<b>TITLE</b>	Pegasus Quantum Front Strut Top Channel
<b>CLASSIFICATION</b>	The CAA have classified this bulletin as mandatory.
<b>COMPLIANCE</b>	Inspection before further flight.
<b>APPLICABILITY</b>	All Pegasus Quantum and Quasar aircraft.

Fig 1 Front strut channel connected **WRONGLY.**

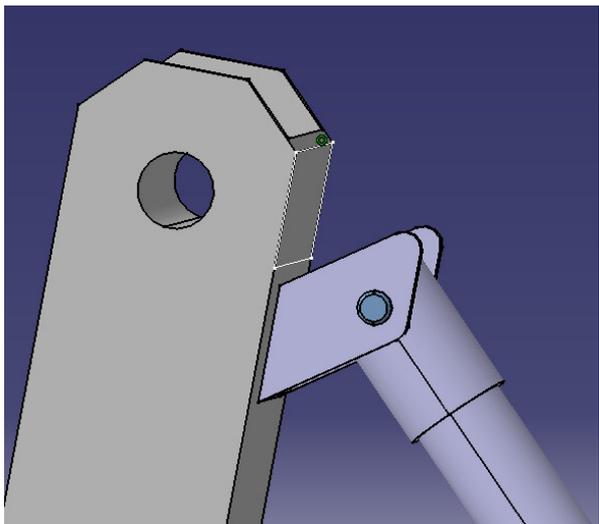
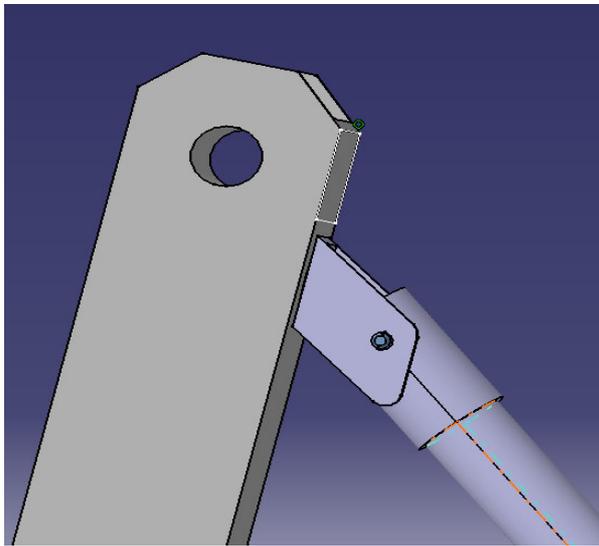
**INTRODUCTION -**  
It has come to our attention that the Quantum and Quasar front strut assembly can be miss-rigged, with the top channel fitted upside down (see fig 1). If the aircraft is operated in this condition, there is a significant risk of the channel being damaged and failing. Failure of the front strut channel applies a large rearwards bending moment to the main pylon, causing it to distort or possibly to fail.

**INVESTIGATION-**  
If the top channel is fitted upside down, it is subject to a levering action, causing it to distort and possibly fail. The problem is made worse because the front strut assembly is shortened, introducing an increased tensile preload.  
Fig 2 shows the correct orientation.

- 1) Before further flight, inspect the channel for distortion. If any is suspected, unbolt the front strut top channel from the main pylon. Inspect for distortion, also inspect for cracks around the holes and at the corners, using a magnifying glass or dye penetrant. Check the M8 attachment bolt for distortion.
- 2) If there is any distortion or cracking, the channel must be replaced with a genuine factory part ZCH-011.
- 3) Replace the channel using a new M8 nyloc nut, note the plastic washer to allow the channel to swing. Note the bolt must be tight enough to take up any free play, but still enable the channel to swing 15 degrees each way to allow the front strut to clear the screen when rigging.
- 4) Apply placard ZPL-155 on the pylon next to the channel (see fig. 3)
